Attachment C: Plan Comparison Table

Approved Plans	Proposed modification plans
Site Plan DA0350/2022 – Revision 3	Site Plan DAM0043/2024 – Revision 07

**Landscape Composite Plan Groundfloor,
Level 2, 5 & Rooftop Terraces**

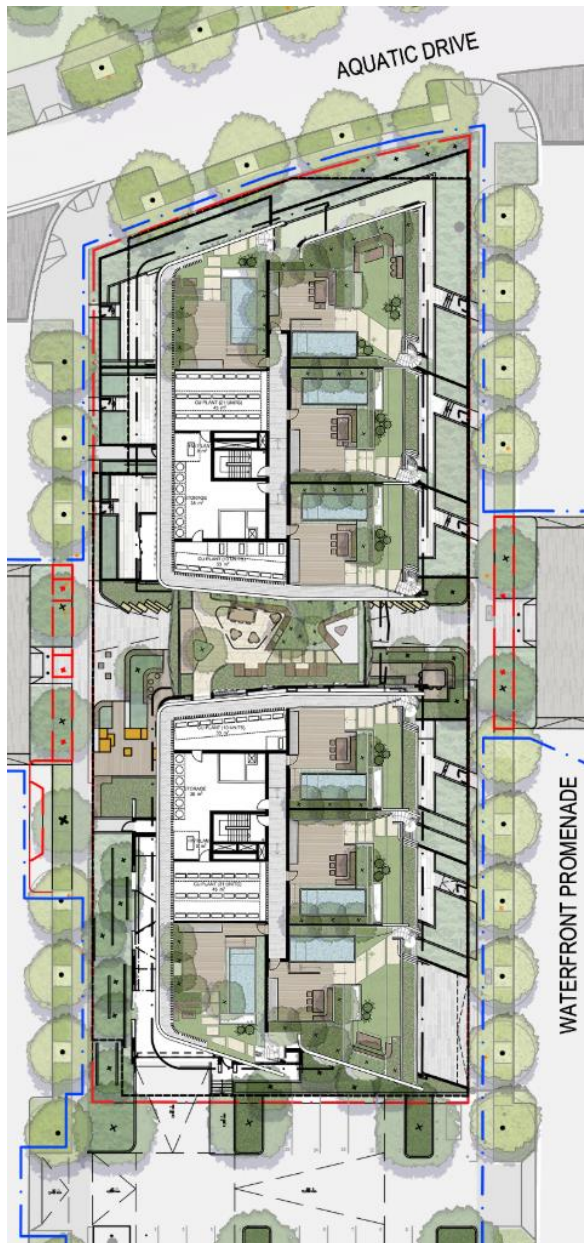
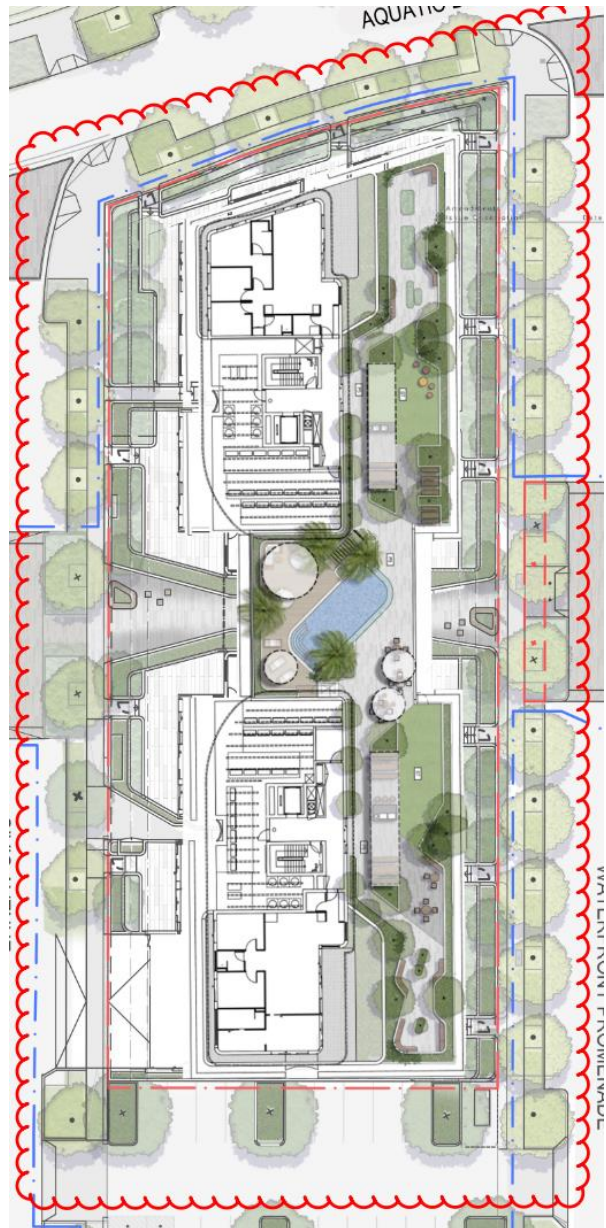
Comment: The amended composite plan depicts changes to landscaping throughout the ground-floor and roof layout.

Landscape Plan Lot D2 Groundfloor Bldg B / DA0350/2022 / Issue H

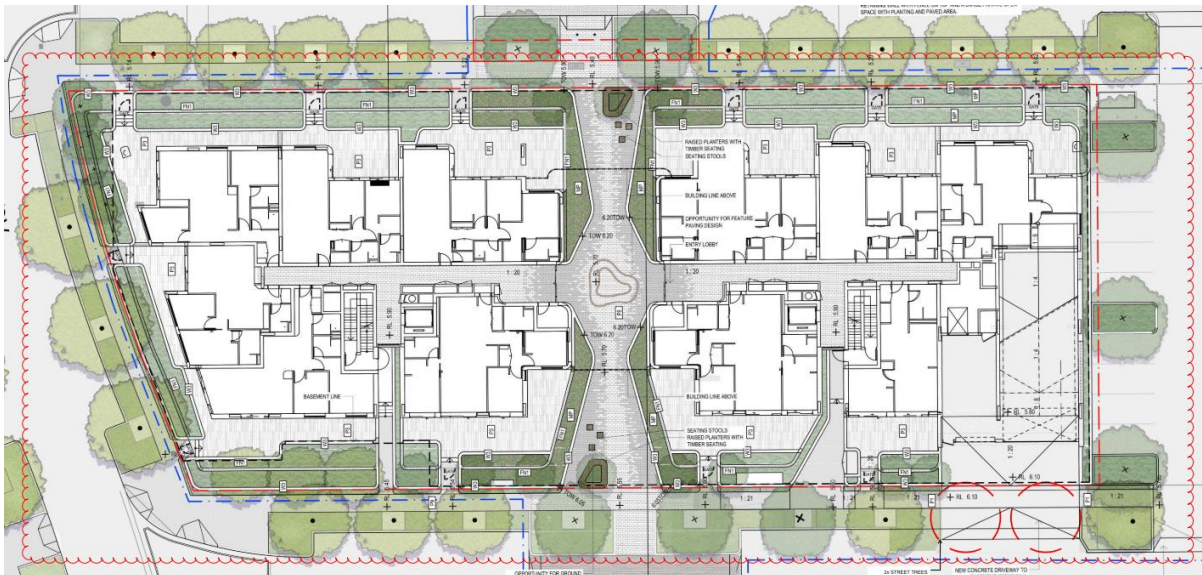
Comment: The modification plans capture changes to the ground-floor through-site access and general landscaping configuration as a result of the apartment floor plan reconfiguration.

Landscape Plan Rooftop Plan Lot D2 – Bld B / DA0350/2022 / Issue D

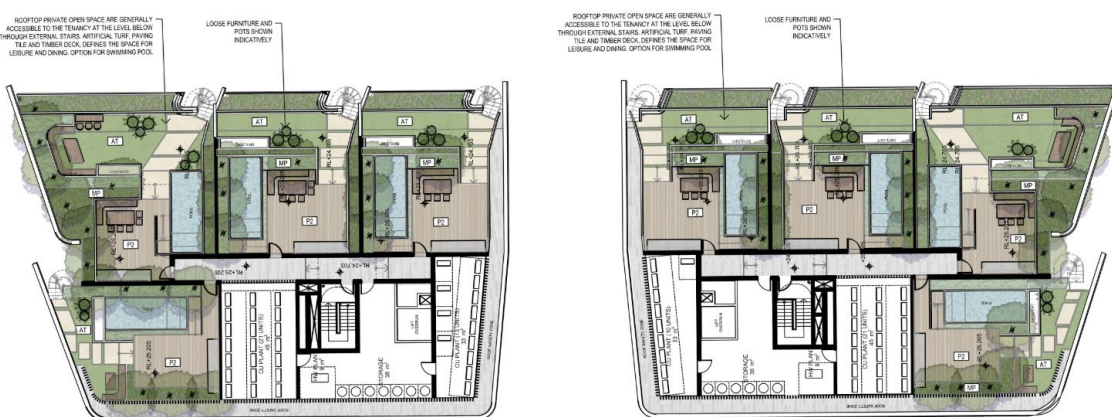
Comment: The modified landscape plan indicates removal of the private access stairs from Level 5 units directly below, and a general reconfiguration of the landscape plan for the rooftop terrace and communal open space.

Sections Bldg B + Through Site Link / DA0350/2022 / Issue C

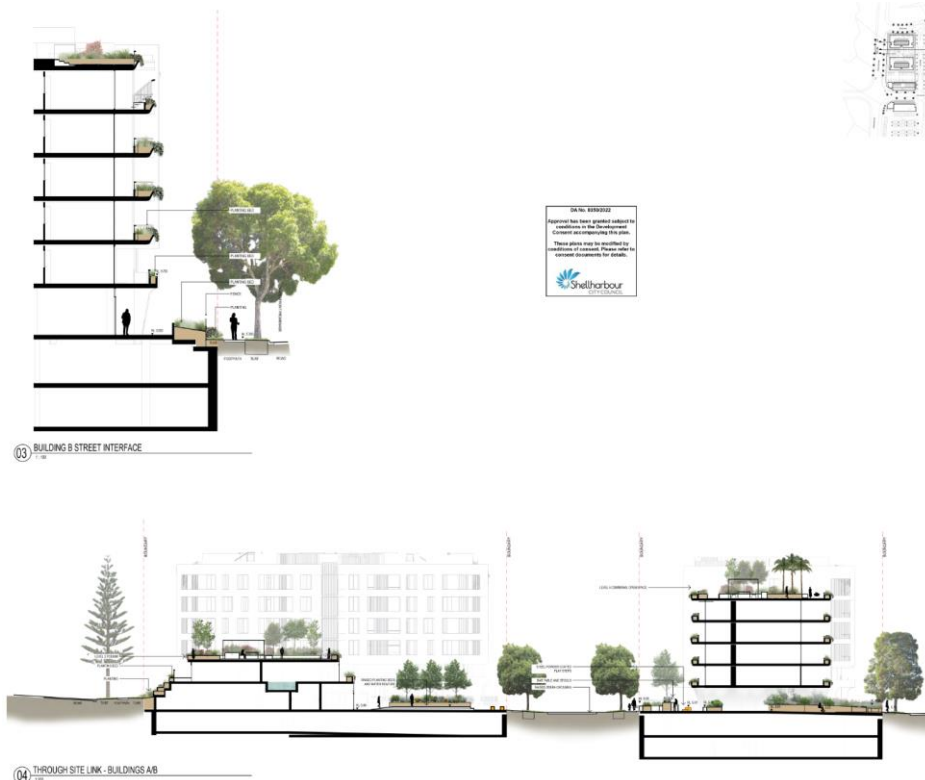
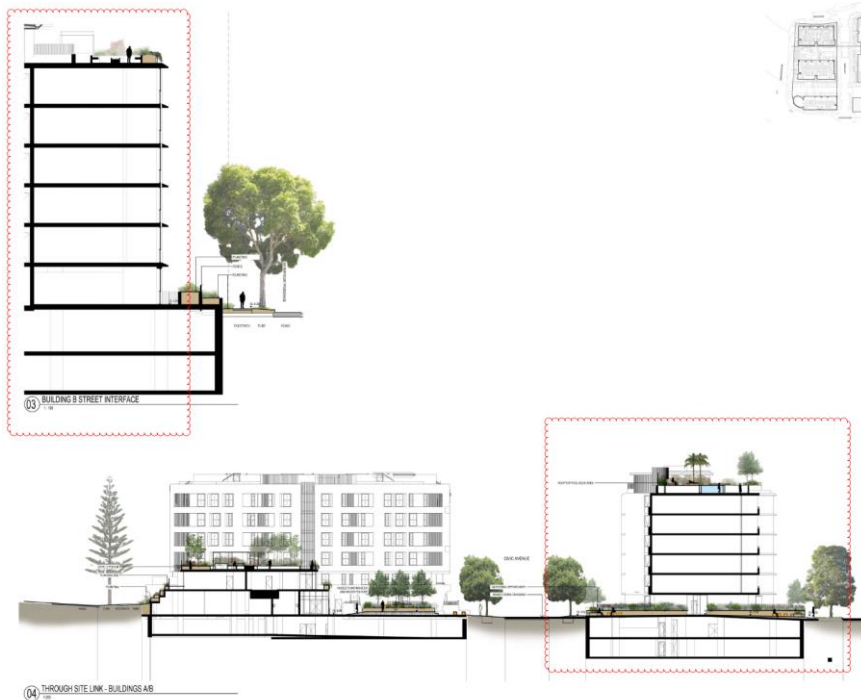
Comment: The landscape sections capture a reduction of planting and garden beds to the façade on each floor. These sections are not the latest iteration; planting beds have been re-introduced to the central rebate and some Level 1 components on the Building B façade, and the landscape plans will be conditioned to be updated accordingly.

The plans otherwise depict changes to the basement, ground-floor and rooftop landscaping configurations.
